2.1.5 AMENDMENT 5: CPW

Timber handrail to CPW west facade reduced

APPROVED ELEVATION
Drawing: 19559-CPA West Elevation

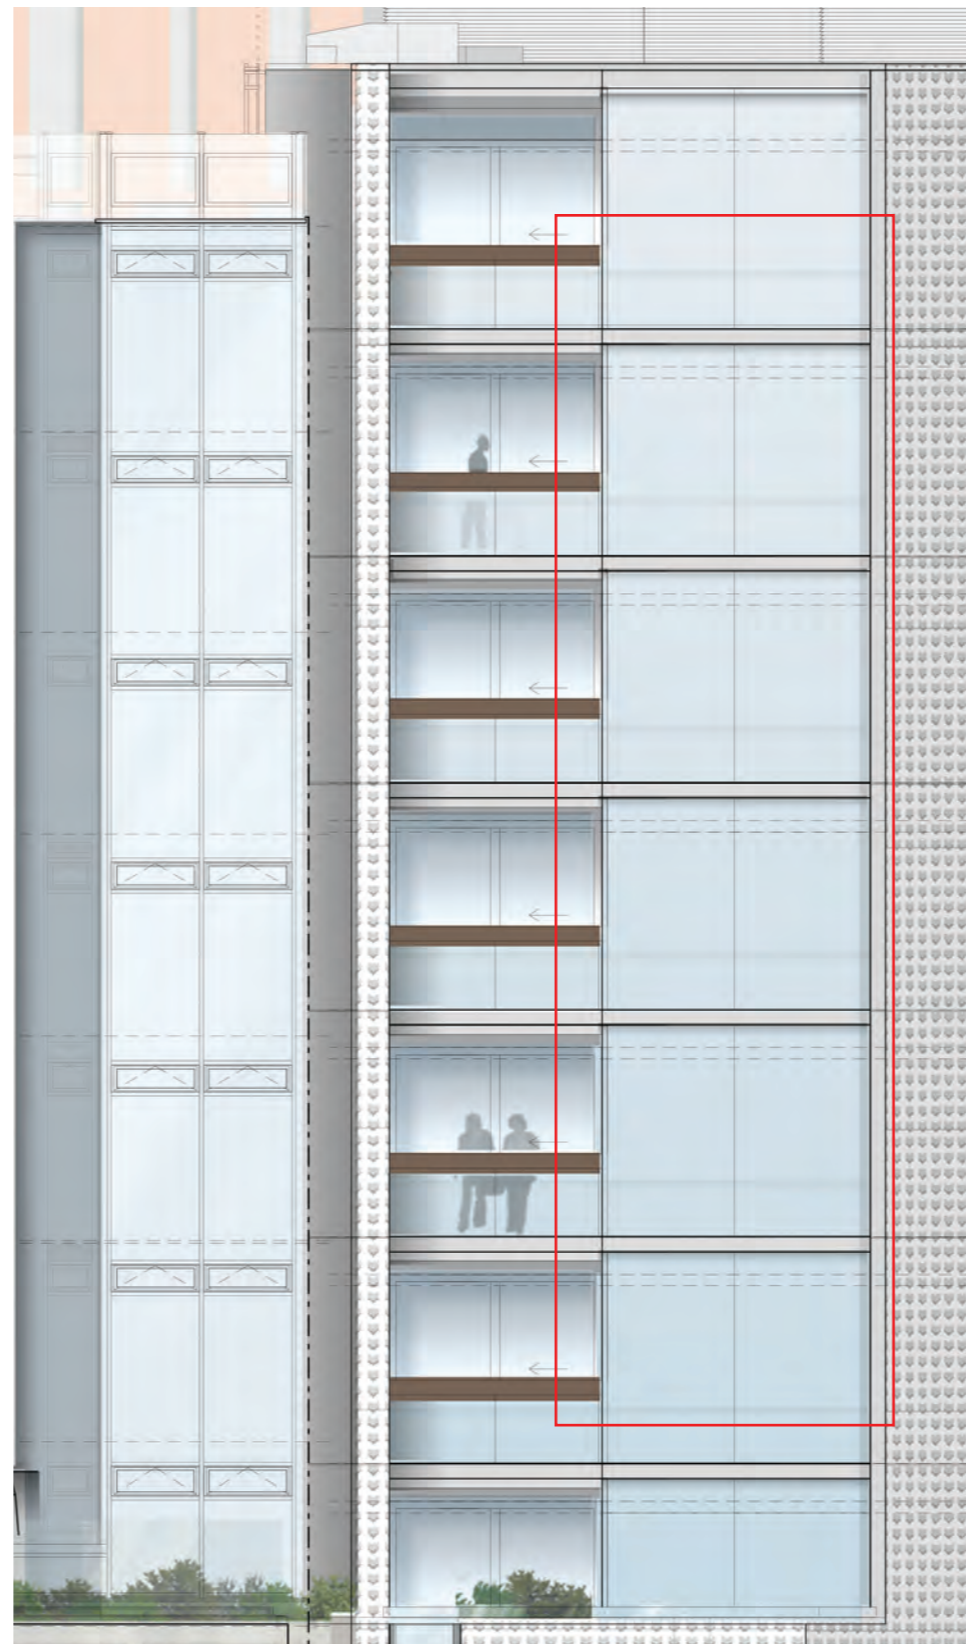
The permitted West elevation of the affordable housing block indicates a hardwood timber handrail across the balconies and continuing along the adjacent glazed facade.

Following stage E design development and subsequent detailed discussions with the glazing manufacturers, it was established that this would be a technically difficult detail to resolve particularly with regard to achieving a weather tight and thermally broken solution. It is therefore proposed to limit this hardwood rail to the balcony areas only. This will also result in an improved residential amenity as these living rooms will benefit from an unobstructed floor to ceiling view looking West.
